Coleman Heights

Re: Final approval of Section A of Coleman Heights Subdivision.

Re: Final application of Section A of Coleman Heights Subdivision.

Re: Final Application of Section A
Coleman Heights Subdivision

SECTION A
PLAN OF SUBDIVISION
FOR
COLEMAN HEIGHTS
TOWN OF NEW WINDSOR, COUNTY OF ORANGE

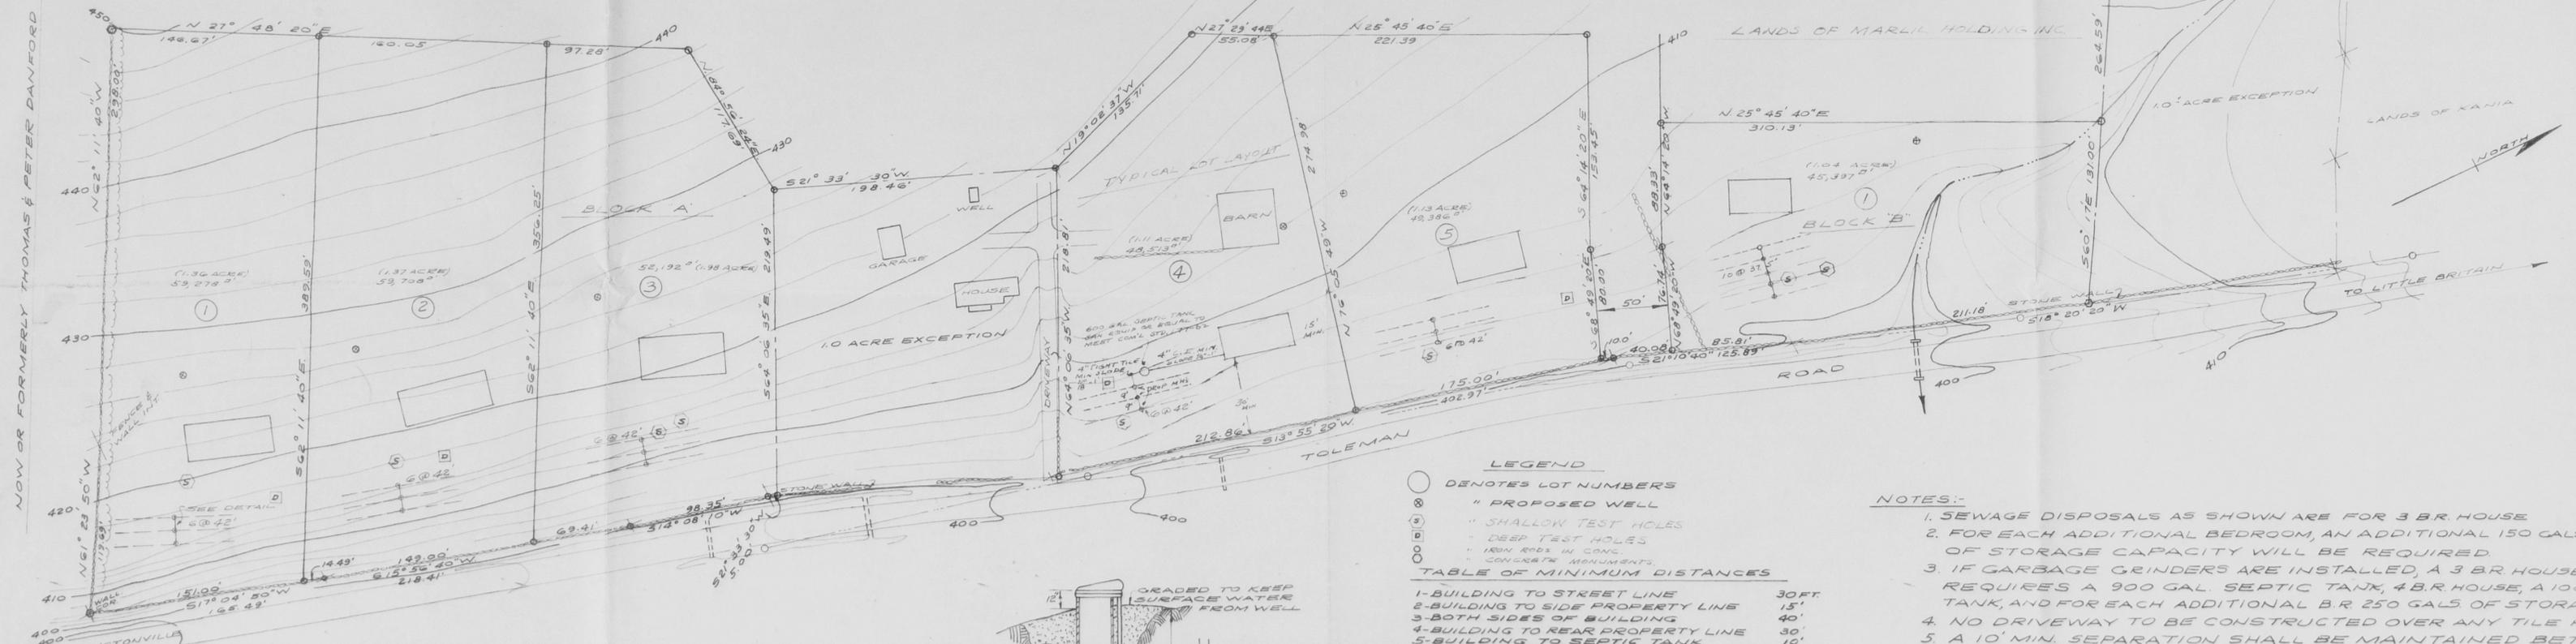
Art. 5-C, Item 3 - Certification of title showing that applicant is owner.

Item 9 - There shall be at least four (4) permanent concrete or stone monuments located on the perimeter of the subdivision and similar markers will be set at property limits, angle points and street intersections.

Art. 5-B, Item 5 - Location of existing location of sewage disposal system.

Item 9 - Profile of proposed grading.

Item 13 - Results of percolation test and deep pit test.

Item 15 - Drainage plan.

Item 16 - Covert design.

Item 21 - Distance to nearest existing street intersection.

Article 5-C Item 3: Attached is a certification of title. *(on plans)*

Item 9: The plans show the location of the requested four permanent monuments and these will be installed. Iron rods will be placed at the other lot corners.

Article 5-B Item 5: The plans show the location of a dry well, which receives waste from the kitchen in the existing house. There is no other plumbing in this house, and the only disposal system is a dry well. If a plumbing system is installed, a new septic tank and disposal field will be necessary.

Item 9: Actually, we are not planning any changes in the grading.

Item 13: Attached are the results of the percolation tests and deep pit tests. *(Sent with plans)*

- Item 15: This item asked for a drainage plan. For the first section all of the drainage goes to existing road culverts, and no changes are contemplated. There will be 12" culverts underneath the driveways. If and when anything is done in the future with the land to the rear, or west, of these lots, that drainage will be conducted to the existing water course.
- Item 16: Culvert design. The only culverts proposed now will be in front of the individual driveways, and these will be subject to the approval of the Town Highway Superintendent. We are not planning on anything in front of the 50' strip, which incidentally, is just about on the highest part of the hill, and may or may not need a culvert in the future.
- Item 21: The location plan shows these distances.
